January 29, 2014

Project Name: Rochester ER STP 0162(19)
Structure Identification: VT 73 Bridge #13 over the Brandon Brook

Re: Precast Structure Proposed by Michie Corporation

2 FOOTING LAYOUT PLAN VIEW
N = 1"=20'

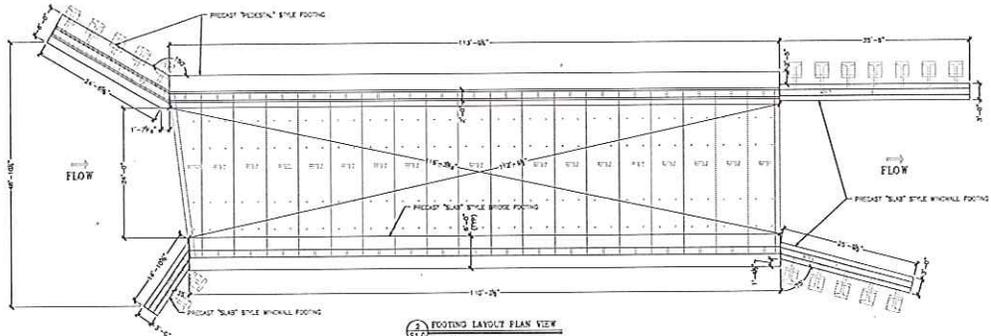
2. The layout and bottom of footing elevations generally conform to the Contract Plans. The footing configuration, size, and thickness are different from that shown on the plans. Per note 44 on sheet 19 of the Contract Plans, all precast components, including pedestals and footings, shall be designed by the fabricator and stamped by a Professional Engineer in the State of Vermont. In conformance with the Contract, design calculations shall be submitted with the shop drawings when transmitted for approval.

- We are proposing slab style footings for wingwalls 2, 3, and 4. Wingwall 1 will remain a pedestal style footing due to the stream inlet elevation.
- We are proposing that the wingwall footings be 3'-0" wide, as opposed to 6'-0" wide as detailed on the contract plans. This is the standard footing for an anchor style wingwall which is limited in width due to the geometric design of the wingwall anchors. This system has been utilized on similar projects throughout NH and VT and is on the approved list of precast products from the VAOT.

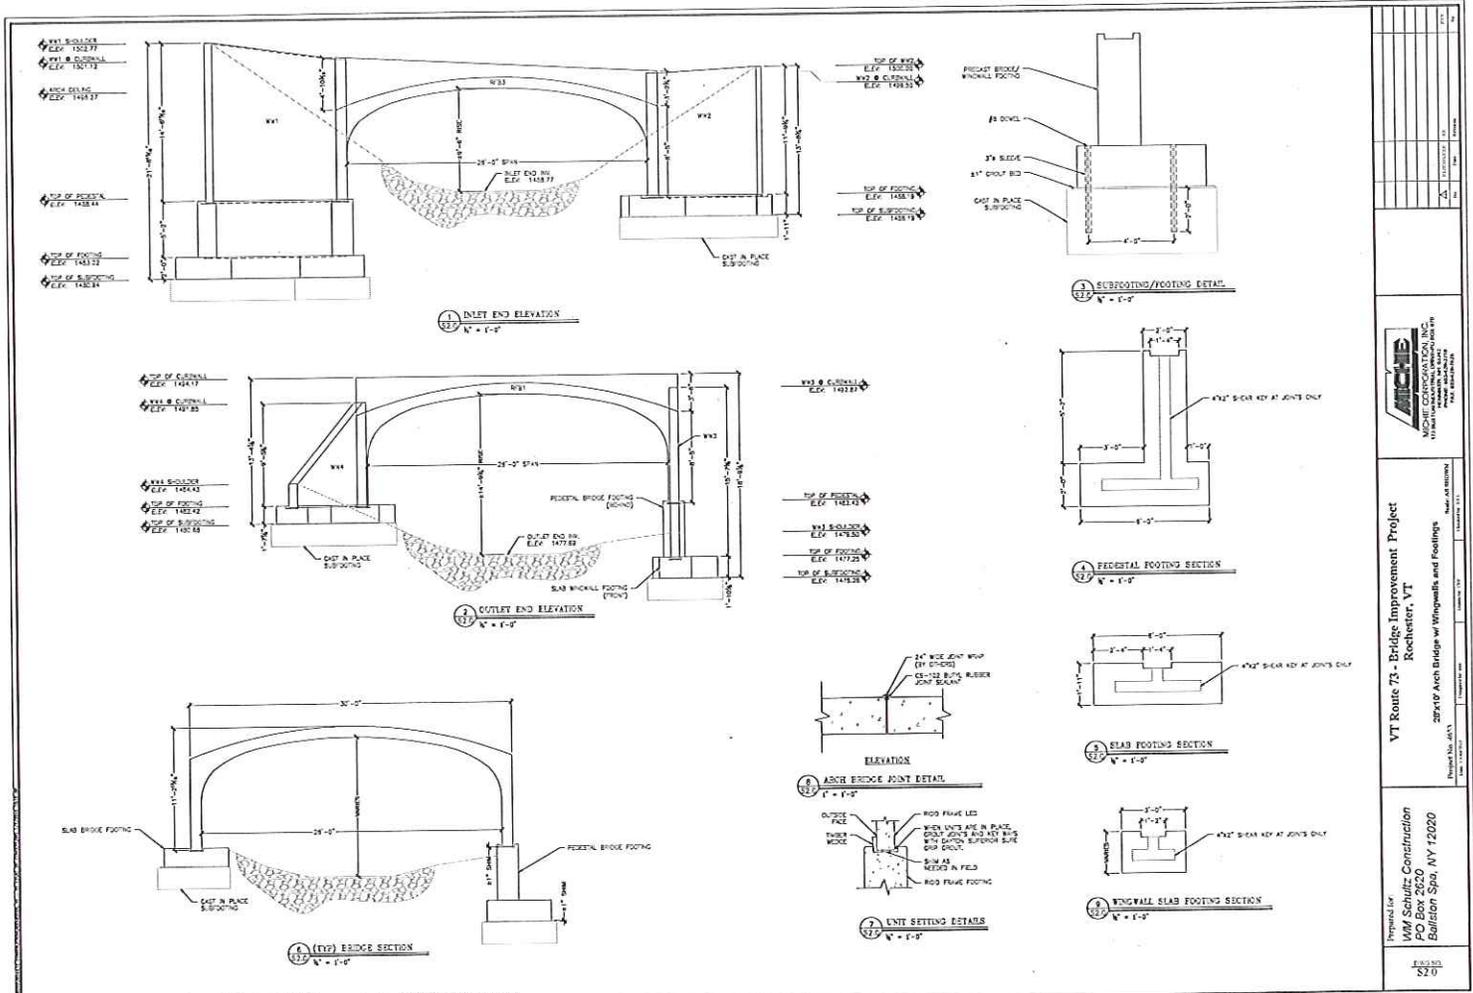
4. Footing to Subfooting Dowels: As shown in Section 3 on Sheet 2.0 of the Conceptual Proposal, the #8 dowels at the toe of the footing are placed approximately 6" from the face of the pedestal. It is our understanding that the precast pedestal will be cast onto the footing at the plant, in which case the dowels will be placed with the pedestal in-place. Will the dowels be drilled and set prior to installing the footings (using a template or other means), or does Schultz Construction intend to place the footings and drill the dowels using the in-place footing as the template? If the footing is to be placed prior to drilling the dowels, please confirm that there is sufficient mechanical clearance from the face of the pedestal for drilling the dowels.

5. Shear keys between adjacent footing and pedestal segments: The Conceptual Proposal shows 4" keyways at joints. VTrans standard practice is to provide a keyway that is 1/3 of the thickness of the footing.

Anchor Plate Detail

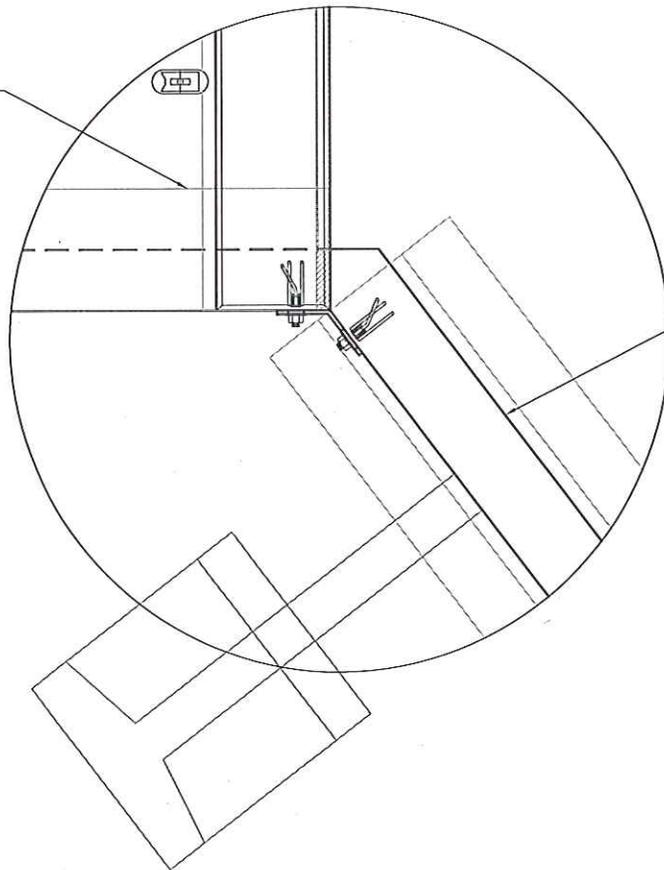
1. Per the VAOT Retaining System Selection Chart, the Contech Precast Anchored Wingwall Systems is approved only for use with Contech Con/Span Bridge Systems. The proposed wingwall system is not Con/Span; however, it is a similar design. In order to accept this concept as submitted, please submit a letter certifying that the system is equivalent to the approved Contech Precast Anchored Wingwall System as given in the VAOT Retaining System Selection Chart. This certification shall be complete with a P.E. stamp from an engineer licensed in the State of Vermont. Full design calculations and details should be submitted at a later date for review and acceptance by the Agency.
